Access Compliance Report

Public Rights-of-Way

Intersection ID: N/A	Main Street: COLONEL FRANCIS J BEATTY PARK DR	Cross Street: PARKGATE DR	Location: NW
ADA ID: 597B51320C9B	Ramp Type: Perp	Initial Pass/Fail: Pass	Overall Compliance: No
Codes/Mitigation Info/Possible Solution		Field Measurements/Component Compliance	
Severity Score: 15

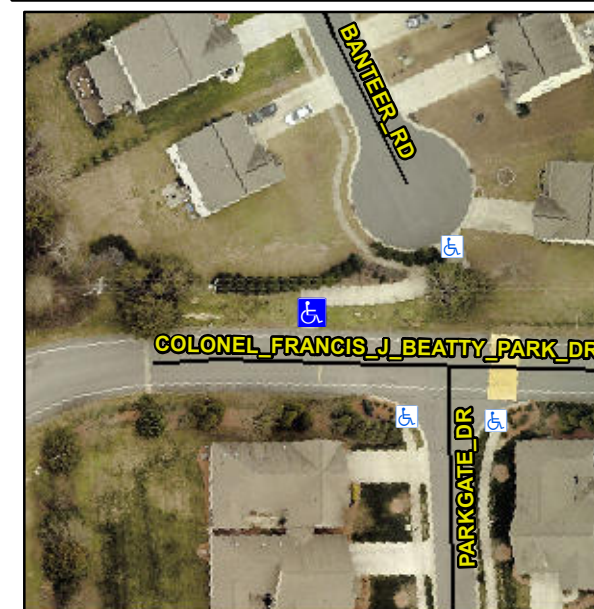
**Remove & Replace Entire Ramp.
Remove & Replace Gutter.**

Not Found, R304.2.2-Perp, R304.3.2-Para, R305, R304.5.4
